II. Drawings

' Appln. No. 10/766,384

Attorney Docket No. 10541-1824 Visteon Disclosure No. V203-0076

Fig. 1

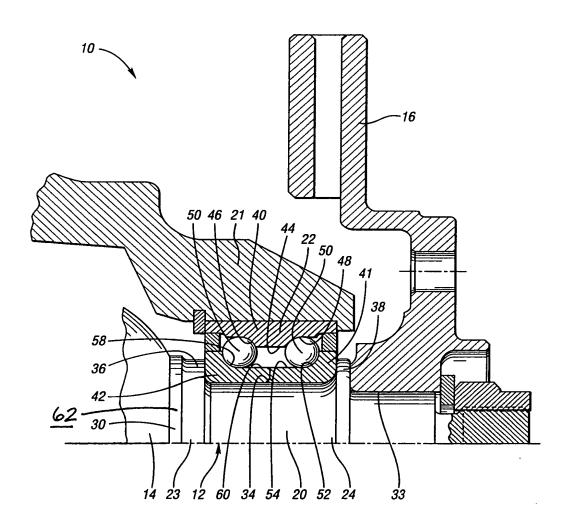
Responsive to the objection to the drawings under 37 CFR 1.83(a) that "the detachable half shaft assembly being detached from the shaft bell" be shown, Applicants have proposed an amendment to the drawings. For clarification purposes, the dashed line underlying the shaft bell 14 has been amended to a solid line to more clearly distinguish between the detachable half shaft assembly 12 and the shaft bell 14. As amended, the drawing shows that the detachable half shaft assembly and the shaft bell are not integral elements, but rather separate components analogous to the relationship between the detachable half shaft assembly 12 and the disc rotor 16.

Responsive to the rejections of claims 1-6 and 9-15 under 35 U.S.C. § 112, second paragraph, Applicants have proposed an amendment to the drawings for clarification purposes to more clearly show that the shaft bell 14 and the detachable half shaft assembly 12 are not integral elements. Further, it is well known in the art that the shaft bell is connected to the front or rear axle of the vehicle and provides support to the whole assembly. By the drawings, it is illustrated that shaft bell 14 engages detachable body 20 (at inboard interface 30) to which disc rotor 16 connects (at outboard interface 33). Moreover, the specification clearly mentions that the detachable half shaft assembly 12 is detachable from the shaft bell 14 or the disc rotor 16. "The detachable half shaft assembly 12 is detached from the shaft bell 14 or the disc rotor 16." Specification, paragraph [0018] (emphasis added); see also claims 1 and 9 as filed. Therefore, it is shown that analogous to disc rotor 16, shaft bell 14 is a distinct element from the detachable half shaft assembly 12.

Rig. 3

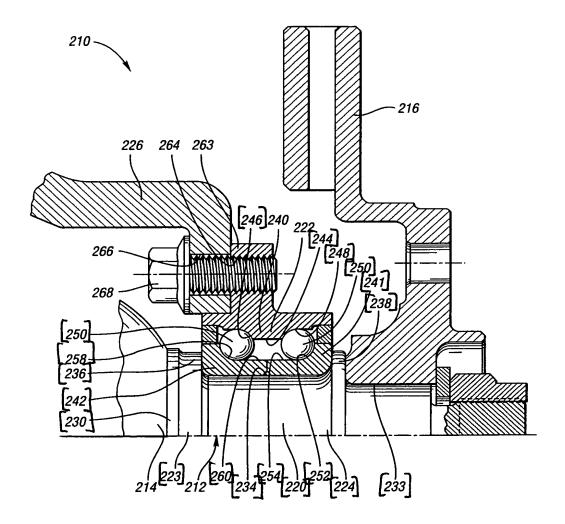
Responsive to the objection to the drawings under 37 CFR 1.84(p)(5) because they included characters not mentioned in the description, Applicants have proposed an amendment to the drawings to remove reference numerals not mentioned in the description. More specifically, reference numerals 144, 148, 150, 158, 160, 134, 154, 152, and 133 have been removed from Figure 2 and reference numerals 241, 242, 246, 244, 248, 250, 238, 233, 224, 252, 220, 254, 234, 260, 223,

230, 236, and 258 have been removed from Figure 3. Reference numeral 123, however, has not been removed from Figure 2 because paragraph [0021] of the specification makes reference to reference numeral 123.
